Tennessee Valley Authority, Post Office Box 2000, Decatur, Alabama 35609-2000

TVA-BFN-TS-414 Supplement 2

**BROWNS FERRY NUCLEAR PLANT (BFN) - REDUCTION IN REQUESTED  
EFFECTIVE FULL POWER YEARS (EFPY) FOR TECHNICAL SPECIFICATIONS  
(TS) CHANGE NO. 414 - PRESSURE - TEMPERATURE (P-T) CURVE  
UPDATE**

PROPOSED TECHNICAL SPECIFICATION (TS) CHANGE TS-414 SUPPLEMENT 2  
MARKED PAGES

**Figure 3.4.9-1  
Pressure/Temperature Limits**

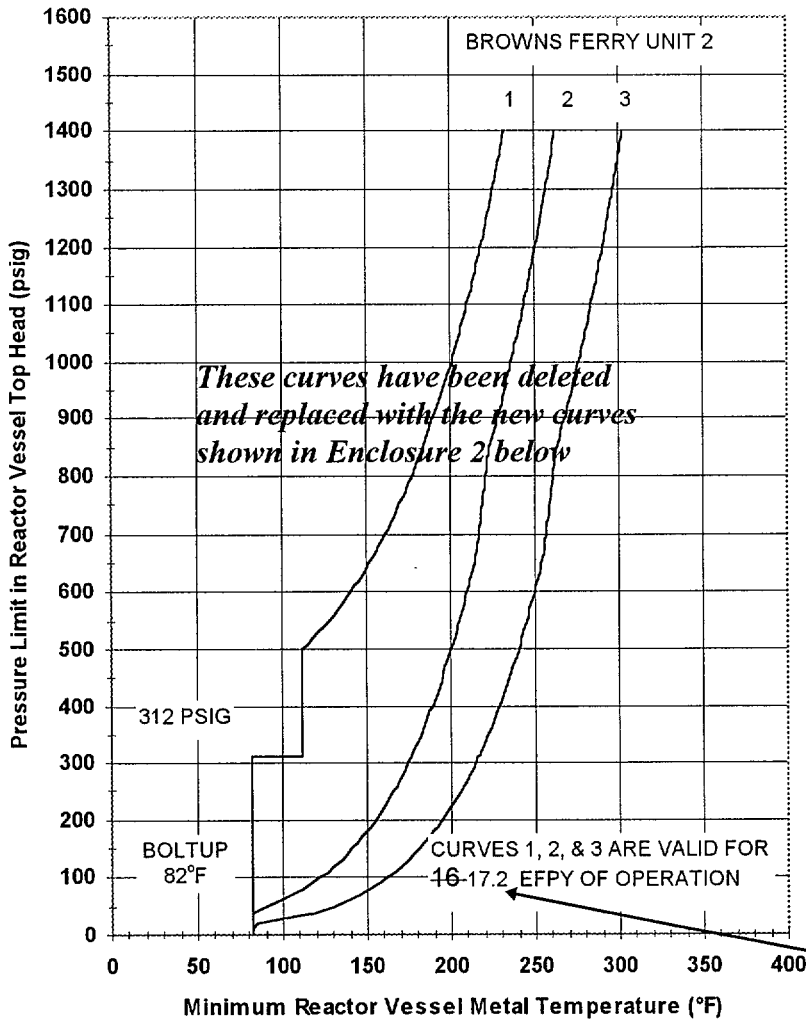
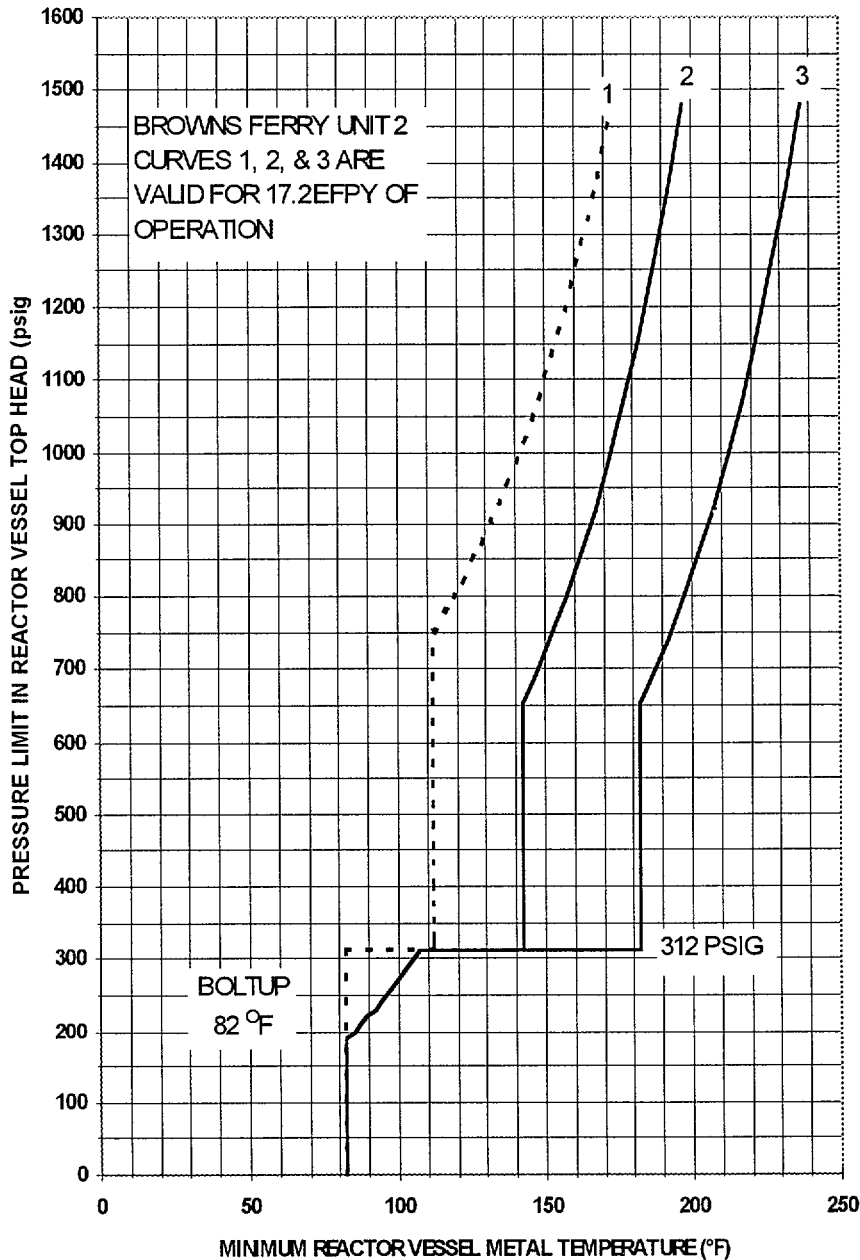
Added "ASME" for additional  
clarity in this note.

*The period of valid use of these curves has been changed from 16 to 17.2 EFPY.*

These curves include sufficient margin to provide protection against feedwater nozzle degradation. The curves allow for shifts in  $RT_{NDT}$  of the Reactor vessel beltline materials, in accordance with Reg. Guide 1.99, Rev. 2, to compensate for radiation embrittlement for 17.2 EFPY.

Figure 3.4.9-1  
Pressure/Temperature Limits

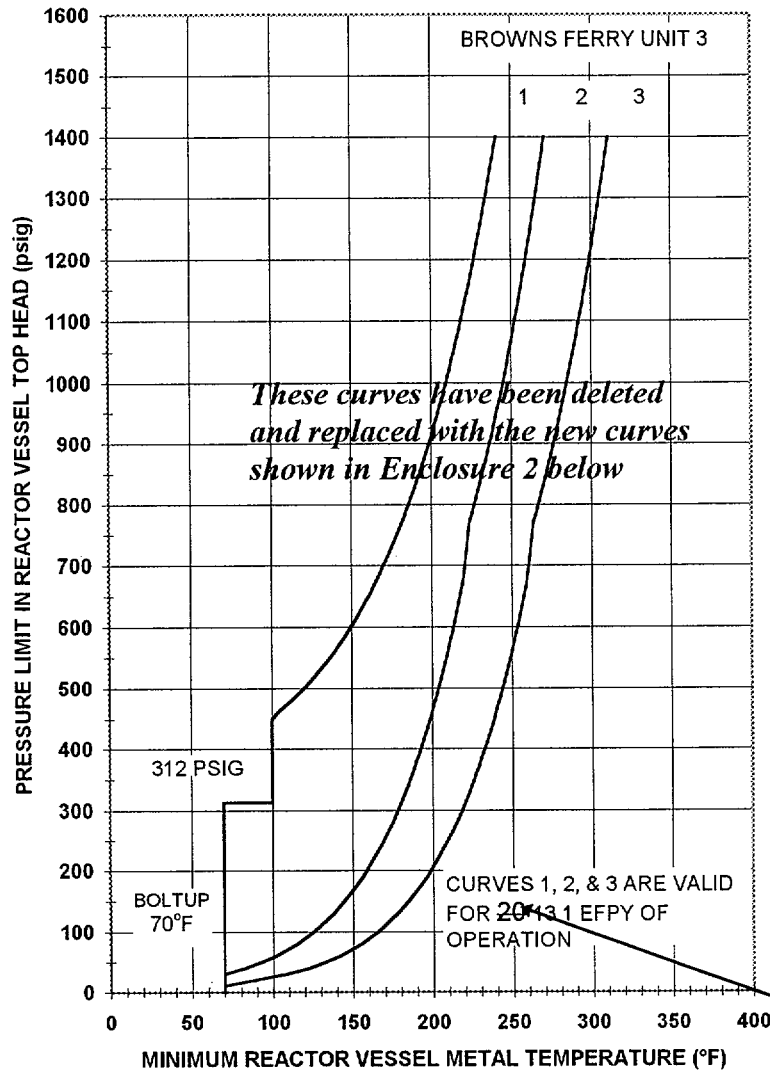
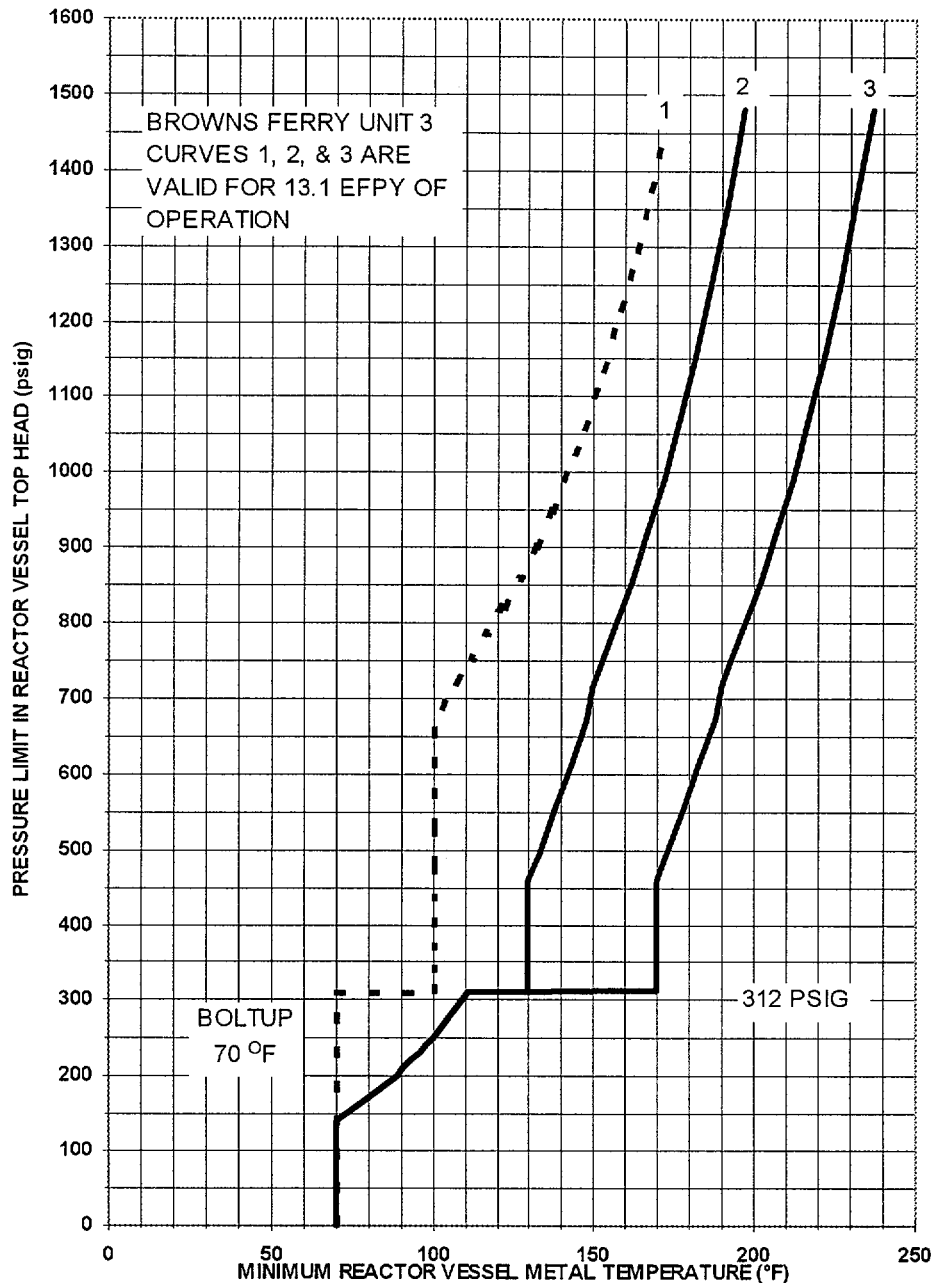
Added "ASME" for additional clarity in this note.

The period of valid use of these curves has been changed from 20 to 13.1 EFPY.

These curves include sufficient margin to provide protection against feedwater nozzle degradation. The curves allow for shifts in  $RT_{NDT}$  of the Reactor vessel beltline materials, in accordance with Reg. Guide 1.99, Rev. 2, to compensate for radiation embrittlement for 13.1 EFPY.
